ONSITE SEWAGE DISPOSAL SYSTEM

PROPERTY ADDRESS: 4807 River Crossing Court

SUBDIVISION: Homewood Crossing

From: Geisert, Andrew
Sent: Monday, May 05, 2014 3:58 PM
To: 'mboyce@eseeng.com'
Subject: Homewood Crossing Lot 71 BAT Plan review

See As-Built Drawing On
Separate Sheet

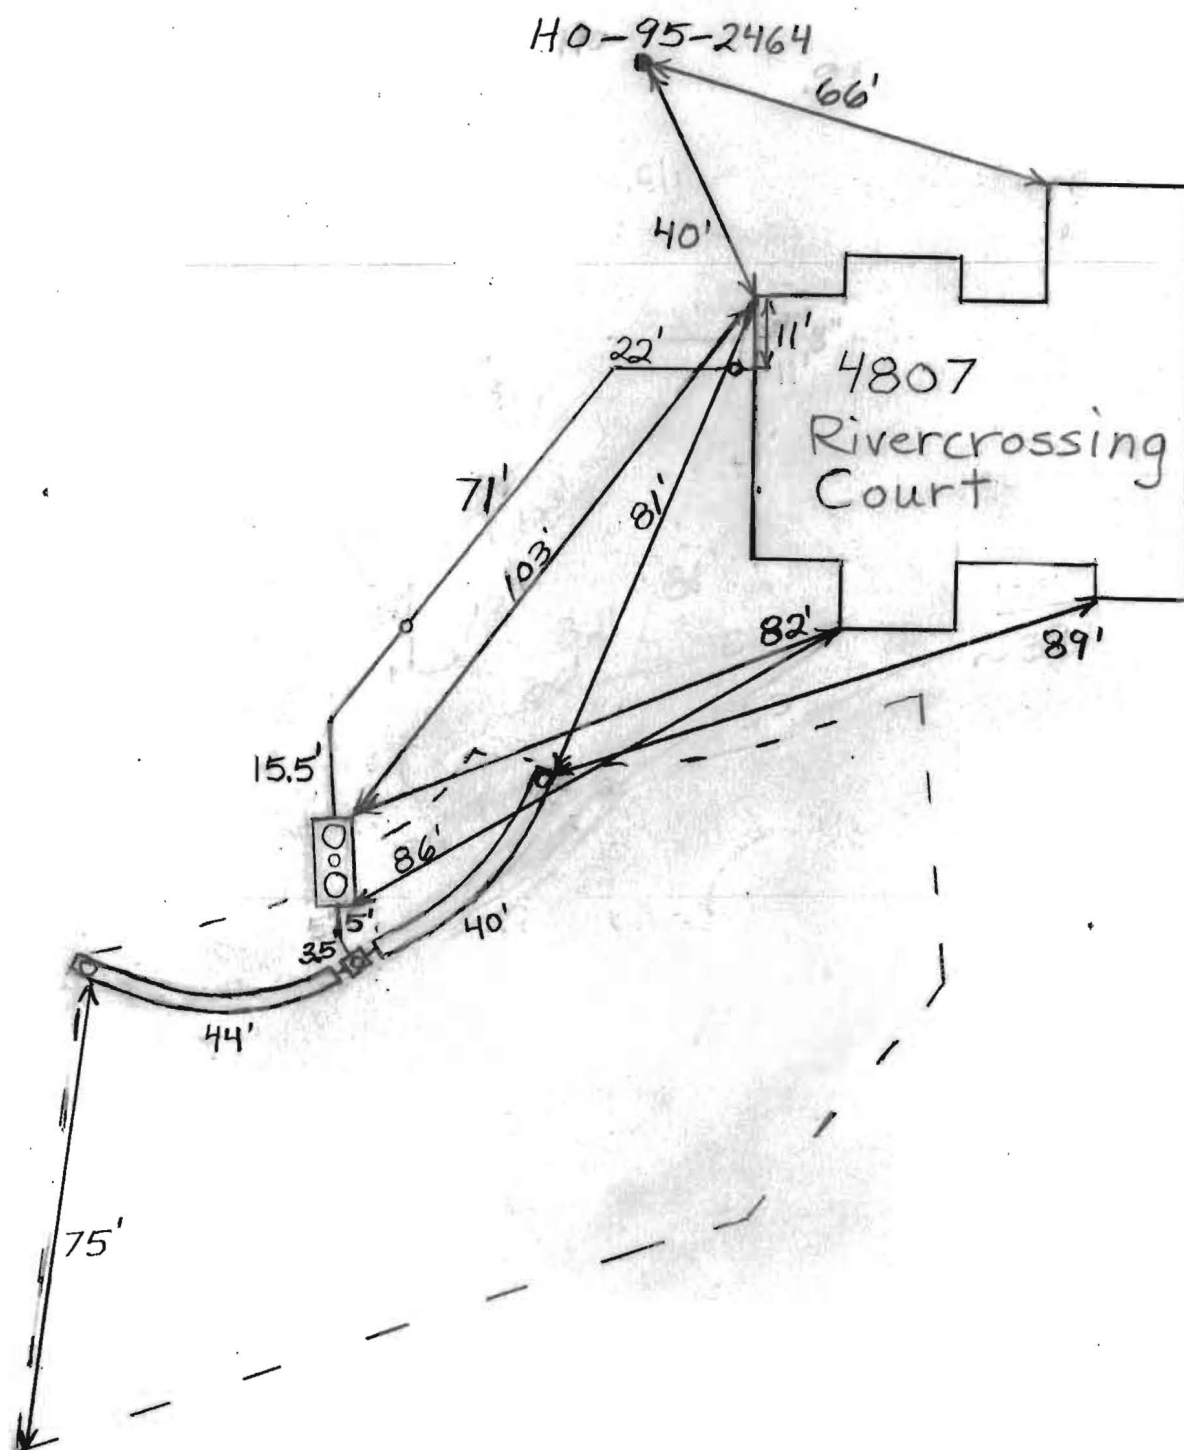
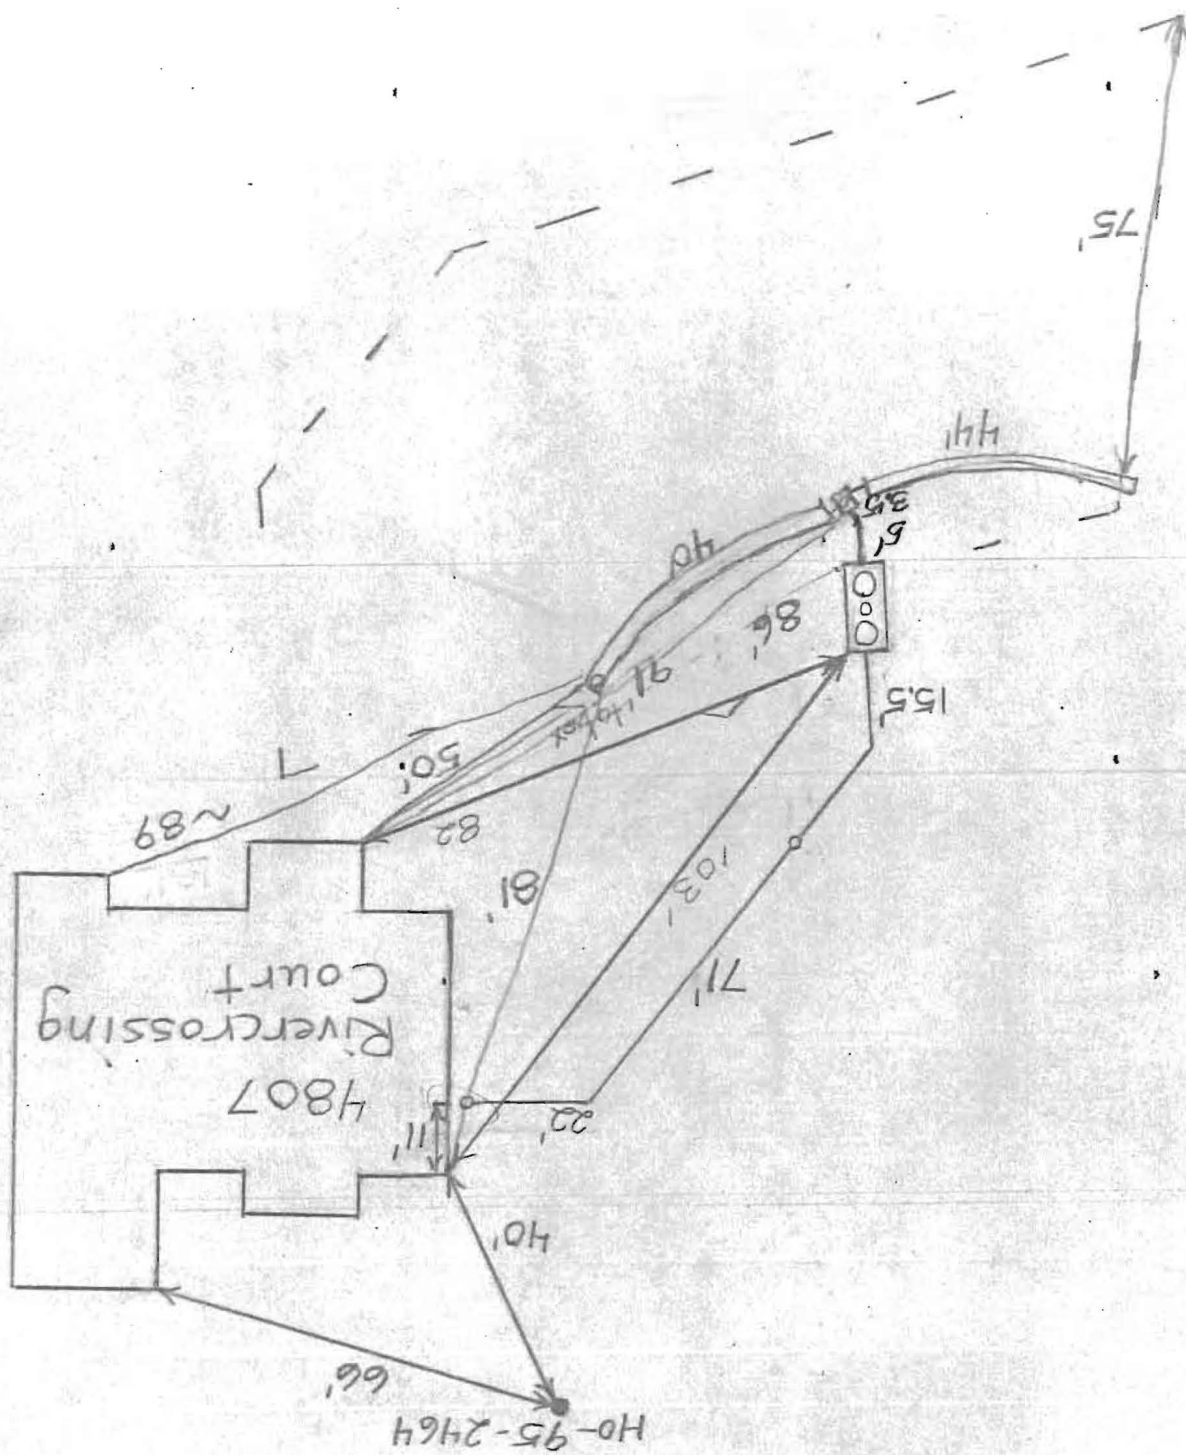
9/12/2014 Cannot lay out trenches. Trees are being removed from easement and some easement stakes have been torn out. O.K. to set tank as shown on plan. (BB)
9/16/2014 Trench layout done. (BB)

9/17/2014 Need house connection. Tank and dist. box set. (BB)
9/18/2014 System finished except for house connection and approval from Babylon. (BB)
10/30/14- SHC inspection completed - connection good - ok to backfill. (BB)
